**Re: Newfoundland and Labrador Hydro 2026 General Rate Application
Requests for Information of the Labrador Interconnected Group**

Requests for Information

LAB-NLH-034 to LAB-NLH-049

Figure 1: Provincial Generation and Transmission Grid Labrador East

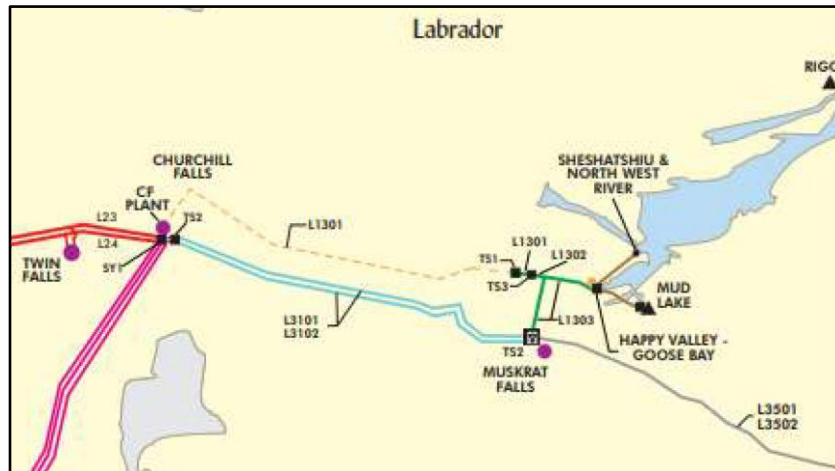
Based on the system configuration in Figure 1, TS1 appears to be behind TS3, and appears to service only an out of service (and soon to be decommissioned) L1301. TS3 appears on the system map of the LIS but is not listed among Capital Additions Labrador Interconnected System in response to IOC-NLH-001. The system maps contained in the NLSO 2026 Annual Planning Assessment are not sufficiently detailed (and potentially inaccurate) for determining which system assets are part of the LIS (and in the LIS rate base) and which part of the Labrador Transmission Assets (and in the IIS rate base).

- 11 Interconnected System filed in IOC-NLH-001 refers to the terminal station labelled in
- 12 Figure 1 as “TS1” at the eastern terminus of L1301 and, if not, to what it refers.

- 13 e) Please indicate whether NLH intends to decommission TS1 shown in Figure 1 as part of
- 14 the decommissioning of L1301 and, if not, why not.
- 15 f) Please confirm that the ~\$0.675 million capital costs of Muskrat Falls Terminal Station 1

- 20 Interconnected System filed in IOC-NLH-001 refers to the terminal station labelled in
- 21 Figure 1 as “TS2” adjacent to the CF Plant generating station, to the terminal station

- 22 labelled in Figure 1 as “TS2” adjacent to the Muskrat Falls generating station, to both, or
- 23 to something else.
- 24 h) Please confirm that the ~\$3.8 million capital costs of Muskrat Falls Terminal Station 2 in

- 27 contained in the Labrador Transmission Assets, Muskrat Falls or elsewhere.
- 28 i) Please indicate whether TS3 exists on the LIS and, if it is on the LIS, explain why no
